Executive Order G-70-25-B

Relating to the Modification of the Certification of the
Atlantic Richfield Balance
Phase II Vapor Recovery System

Executive Order G-70-25-*B*
ARCO Phase II Balance
Vapor Recovery System
Component List

EXHIBIT 1

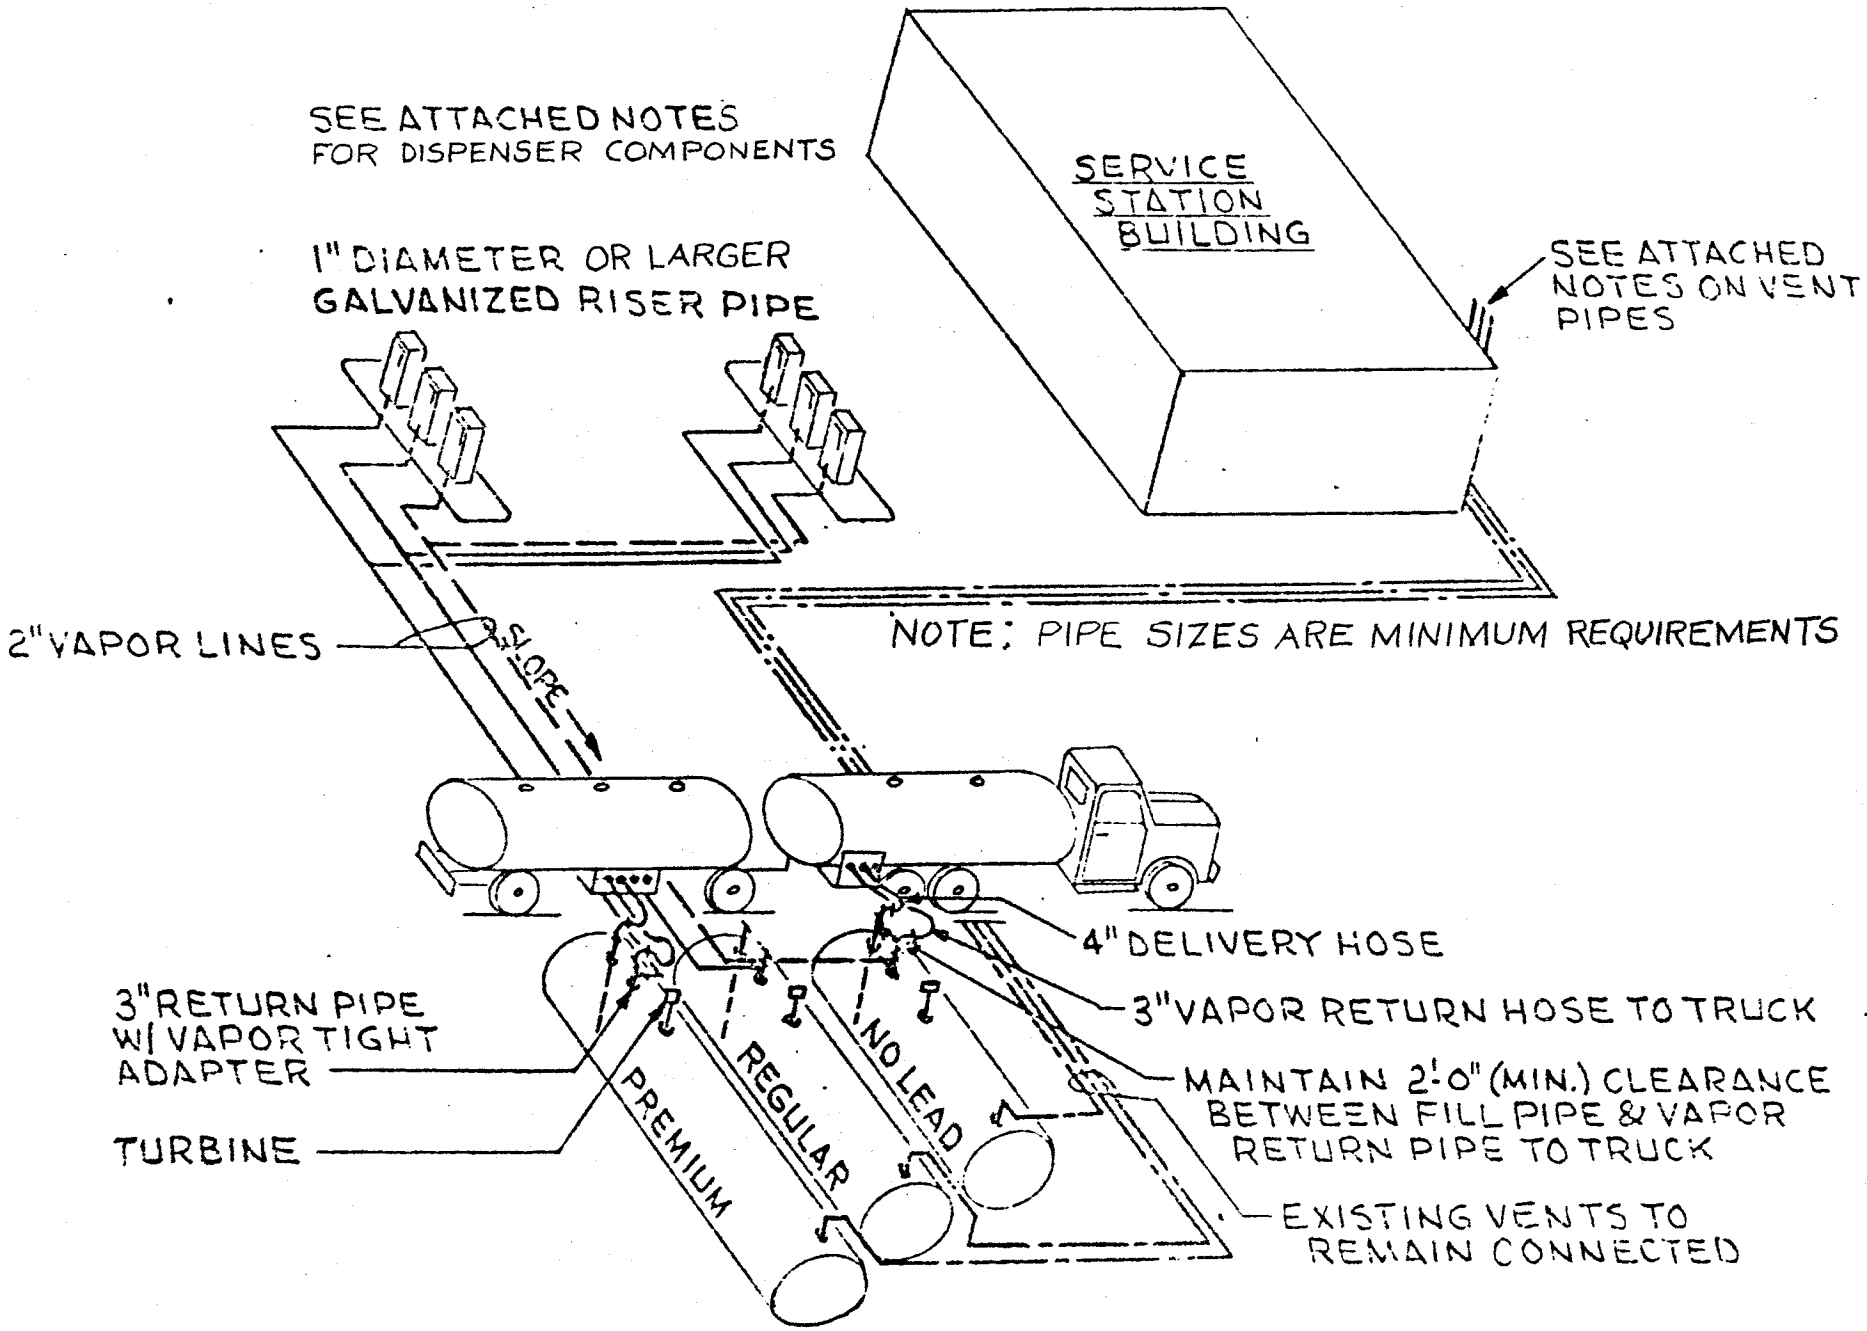
1. Require dual plane 90° swivels at the nozzle end of vapor and liquid hoses, and

2. Eliminate the previously allowed use of a single OPW 78 series recirculation trap on dual dispensers dispensing the same product from both sides.
